ATTACHMENT 5

CORRESPONDENCE RECEIVED – DEVELOPMENT OF LOTS 2 AND 5

Subject: Lots #2 & 5, Council Committee mtg. 5/12

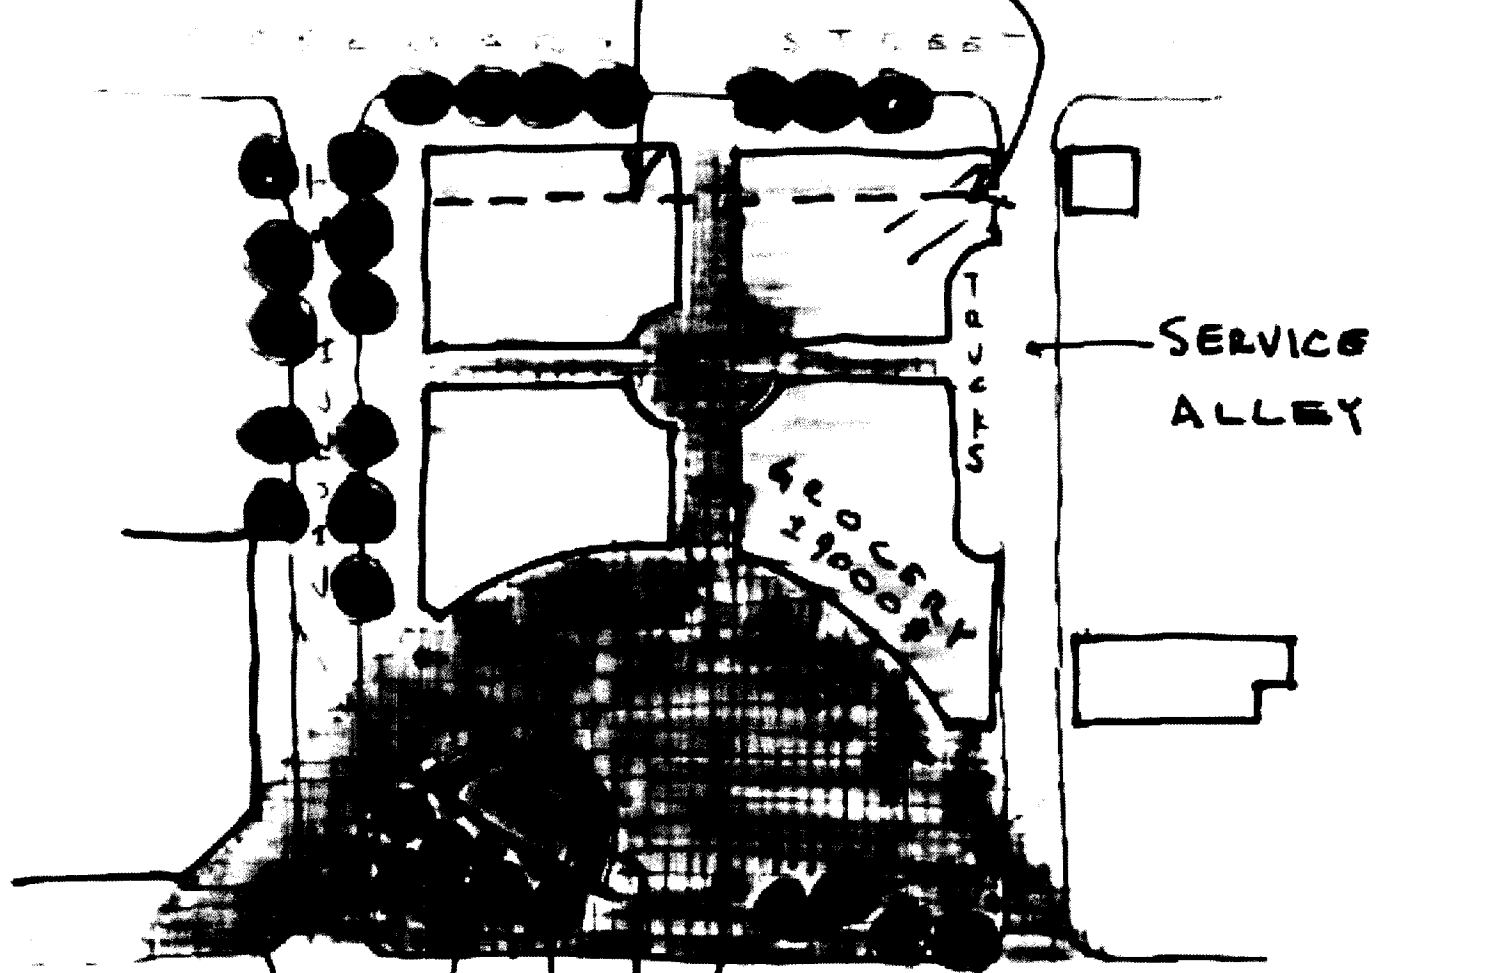
In the sketch titled LOT5JaC I have presented several ideas for your consideration. This is a ground level plan; enclosed heated building areas are shaded yellow. What looks like four buildings is one structure with wide passageways cutting through.

- 1) I let the "Michael Jordan" building frame the space on the west, so that the plaza can be wider on the east-west axis and be open to the full arc of the winter sun.
- 2) The Arcade, which could be 15 to 25 feet deep, serves to create sheltered gathering space for rainy days and hot sunny days, and more intimate kinds of space for sitting with friends. The area I have labeled "arcade" is underneath the upper floors.
- 3) The Arcade could be two floors high in places. I imagine two floors above that and then perhaps stepping back to one or two more. The arcade comes out to the sidewalk on the east side, to provide closure for the east side of the Plaza and buffering from the gas station.

- 4) Think about naming the Plaza for Dr. Martin Luther King, Jr.
- 5) The Plaza paving material extends into Church Street and the sidewalk in front of Jordan's, projecting the arc of the arcade to meet Franklin St.

- 6) I've shown a stage in the SW corner of the Plaza, with a moat of water. When the stage is not being used for events, it could be a "sparyground" in summer. I think it is important for the Plaza to have some kind of raised area for performance, oratory, etc.

- 7) There is a wall, perhaps of some kind of masonry material, behind the stage. The wall follows another arc which I think helps to emphasize a relationship to nature, the solar system, the seasons. On the street side the wall is for remembrance - it could be about Dr King, or it could be a memorial for Chapel Hillians who have died in war.

- 8) I've shown a grocery in the southeast quadrant of the building, about 8,000 to 10,000 square feet. Unless you are dead set against Weaver Street Market operating a store here, I strongly recommend you consult with Weaver St about whether they'd be interested in doing a store there. I'm not trying to sell WSM, but I think a grocery store is one of the strategic elements for reinvigorating the downtown and enticing people to live there. I don't think a 3000 sq ft specialty food store will do the job.

- 9) I've shown a service alley for truck delivery, solid waste pick-up, etc, on the east side of the structure.
- 10) Where the service alley meets Rosemary could be the entrance to the underground parking. This scheme does not call for any parking at grade or above on this site.

CONCEPT 5A

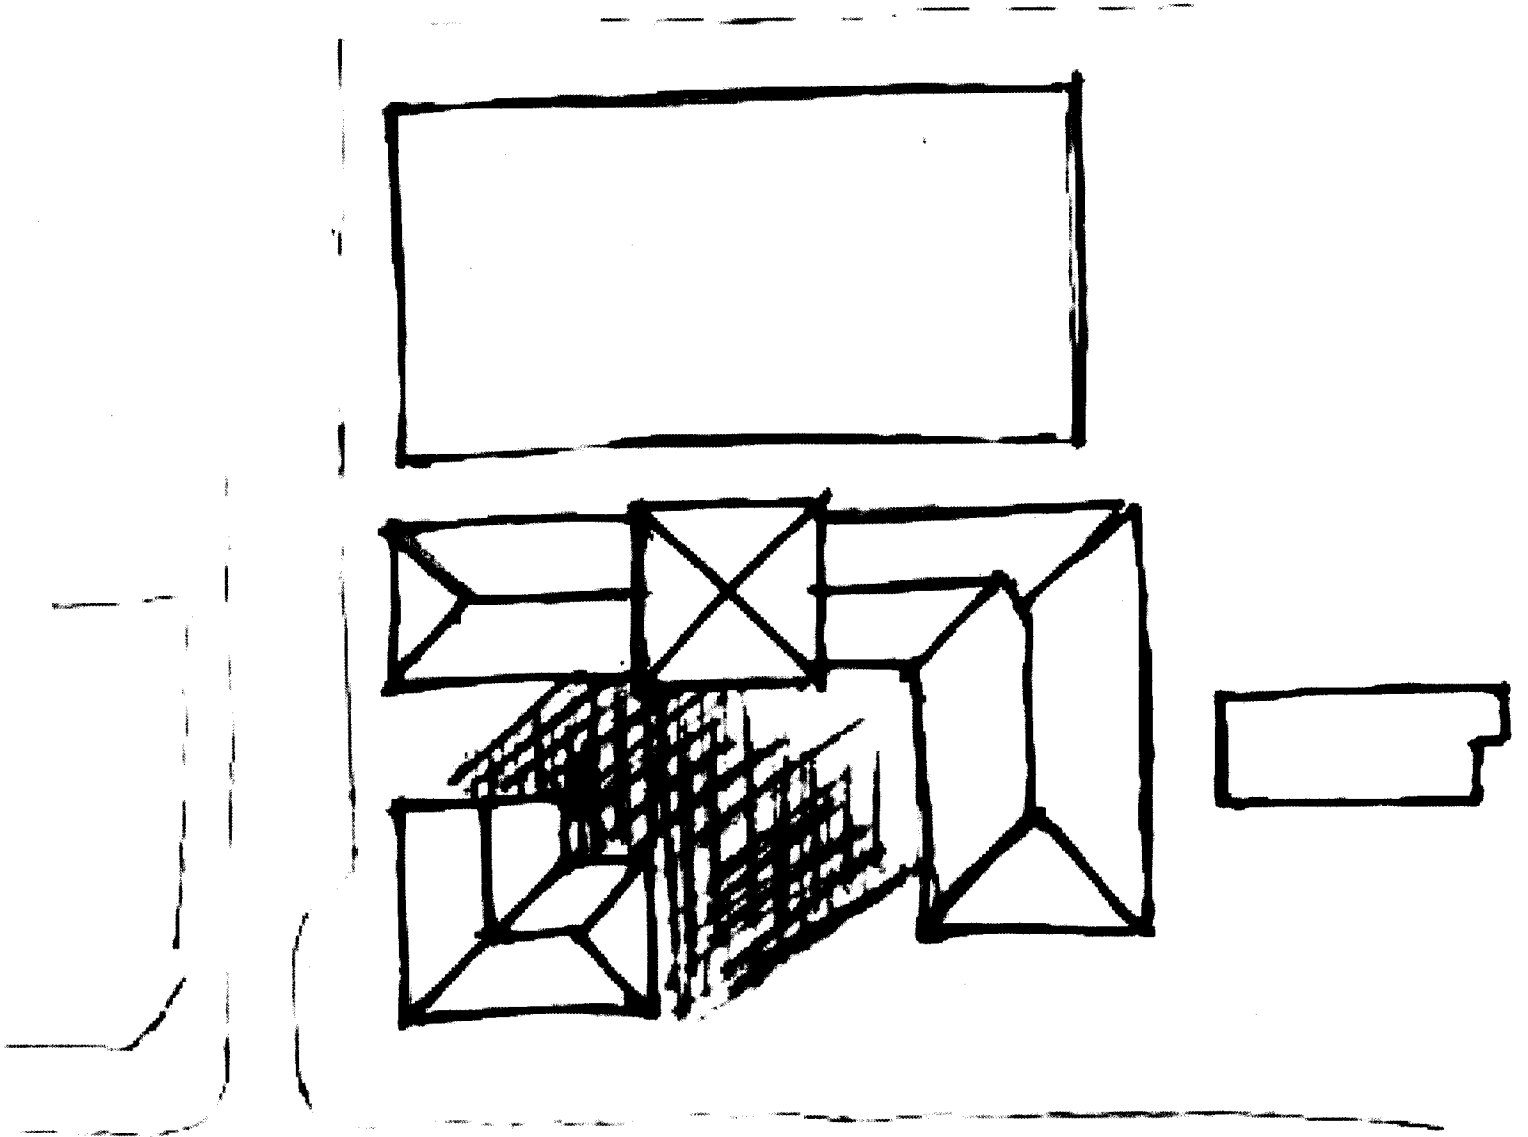
My drawing LOT5A shows winter afternoon shadow cast by the building at the southwest corner of the plaza. I believe I heard Mr Stainback say over the phone that he really liked this building where it is. I think it compresses the space and as my sketch shows it produces a lot of shadow on those winter afternoons. I think the Plaza opens up much better to the afternoon sun without this building. If the square footage is important, it would be better to make the plaza more shallow. I think it works best if it spans most of the Franklin Street face.
